The Secretary
NSW Department of Planning, Industry and Environment

1 May 2021

I refer to the Department's attached email of 28 April 2021 regarding State Significant Development SSD-9522 Kemps Creek Warehouse, Logistics and Industrial Facilities Hub MOD 1 - Changes to Lot 5 for 'Modification of the site layout to accommodate changes to Lots 5-8' at 657-769 Mamre Road, Kemps Creek (Lot 34 DP 1118173, Lots X & Y DP 421633, Lot 1 DP 1018318, Lot 22 DP 258414). Submissions need to be made to the Department by 13 May 2021.

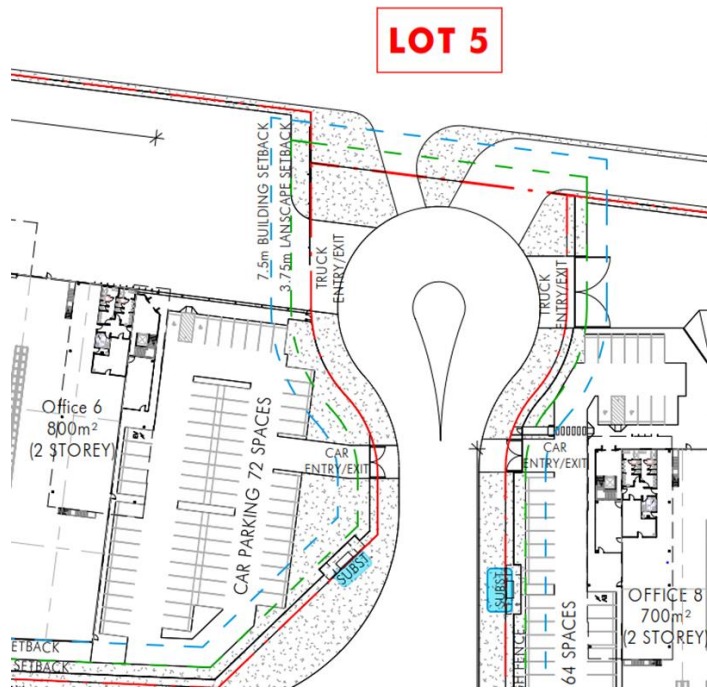
Endeavour Energy has noted that as shown in the following extract of Site Plan (Warehouse 6 & 8) provision has been made for two padmount substations.

From Endeavour Energy's perspective the fact that provision is being made for a padmount substation is a positive. Endeavour Energy's general requirements is for a padmount substation to be at ground level and have direct access from a public street (unless provided with appropriate easements for the associated underground cables and right of access).

A4.3 - Padmount easements and clearances

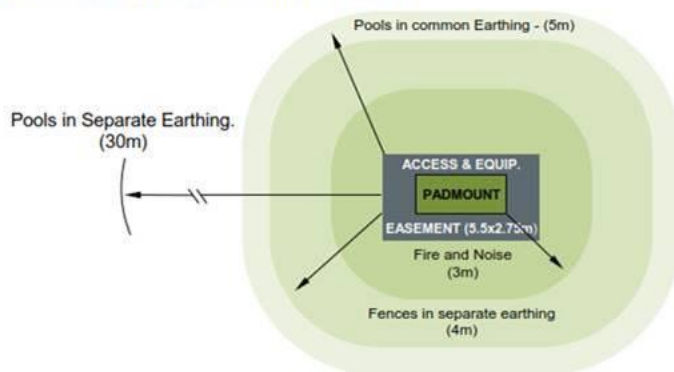
As shown in the following extract of Endeavour Energy's Mains Design Instruction MDI 0044 'Easements and Property Tenure Rights', Figure A4.3 'Padmount easements and clearances', padmount substations require:

- Easement with a minimum size of 2.75 x 5.5 metres (single transformer).
- Restriction for fire rating which usually extends 3 metres horizontally from the base of the substation footing / plinth and 6 metres vertically from the same point.
- Restriction for swimming pools which extends 5 metres from the easement (which is usually not required for non-residential development).

The easement should not cross property boundaries but the restriction/s may affect any adjoining property provided they are able to be registered on the title to that property. In addition the following matters also need to be considered in regard to the fire restriction:

- Personnel access doors and fire exit doors to a building are not permitted within the fire restriction area.
- Gas mains/pipes shall not pass through the fire restriction area.

- A 10 metre clearance distance shall be maintained between substation and fire hydrants, booster valves, and the like in accordance with AS2419.1 'Fire hydrant installations System design, installation and commissioning' as updated from time to time.
- Consideration should be provided to the appropriateness of the landscaping relative to the fire restriction for the substation. Any landscaping that potentially could transfer / provide connectivity for flame or radiant heat from a fire in the substation to a dwelling or building should be avoided.
- The storage of and / or use of flammable, combustible, corrosive or explosive material within the fire restriction should be avoided.
